VILLAGE OF
OAK BROOK
Illinois

ITEM 5.B.
EXETER 711 JORIE, LLC
Variation – Parking Regulations

STAFF REPORT

CASE NO: 2019-05-ZO-VAR

FILENAME: 10103.02GM01
DATE: 08/22/18
JOB NO. 10103.02
SHEET GM1 5 OF 15

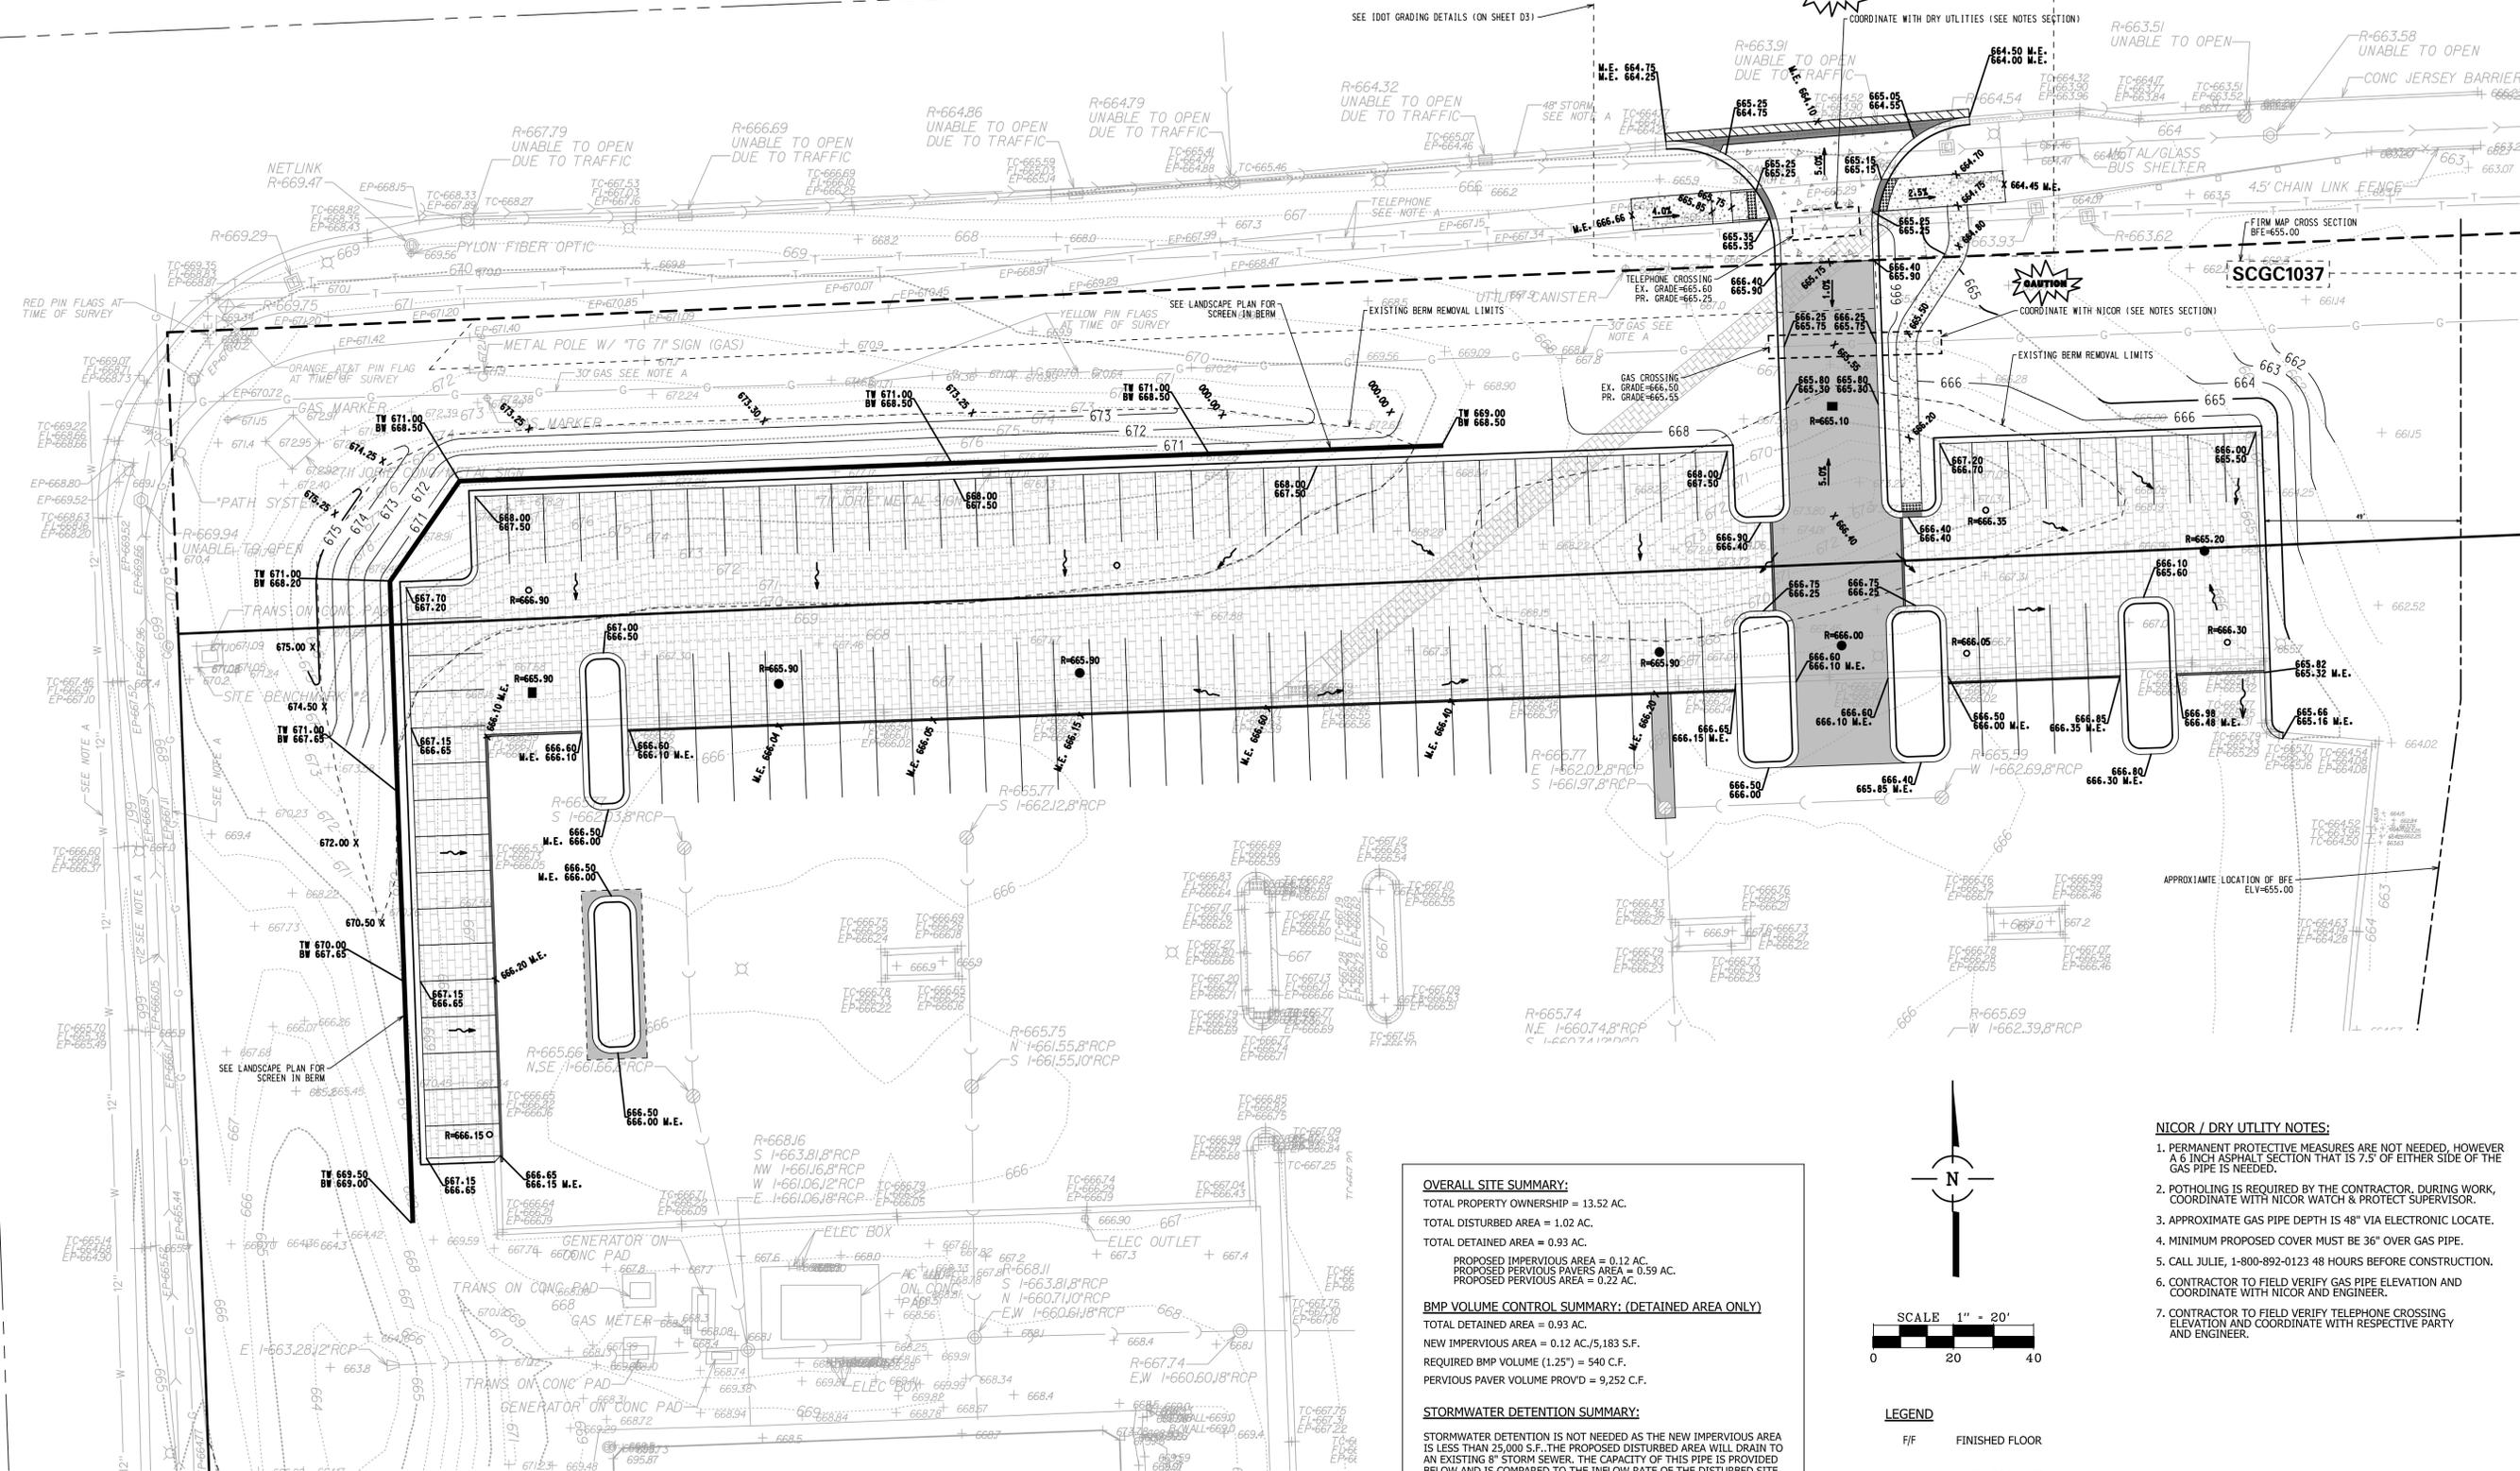
COMMENT 1: Please note that the location for your proposed access to 22nd Street will require light pole relocation in accordance with the enclosed "IDOT District 1 General Guidelines for Lighting Design."

COMMENT 2: Due to the severe parkway slope, the existing bike path will need to be readjusted in accordance with the "ADA Standard for Accessible Design" guidebook.

COMMENT 3: Redesign your proposed access driveway so that the high point is located at the State right of way line.

COMMENT 1: Shift the proposed right-in, right-out (RI-RO) access driveway as far east as possible to achieve at 500' spacing from the intersection of 22nd Street and Jorie Boulevard. An eastbound right turn lane will be required if this distance cannot be achieved.

COMMENT 2: Provide a roadway striping plan sheet in your plans.

RESPONSE 1: Light pole relocation will not be needed as the proposed access driveway was moved east and no longer conflicts with any existing poles.

RESPONSE 2: The existing bike path is being modified. Please see new proposed bike path just east of the parkway. The bike path is in accordance with ADA standards.

RESPONSE 3: Noted. The highpoint of the access driveway is at the State right-of-way.

RESPONSE 1: The access driveway was only shifted 475' east. The access cannot be shifted further because it would require the existing Bus Stop, Guard Rail, and Bridge to be impacted. A right turn lane is not feasible as it would require significant relocation of dry utilities, light poles, and signal improvements.

RESPONSE 2: A roadway striping plan is not provided as a right turn lane is not being proposed and there is an existing barrier median that prevents left turns.
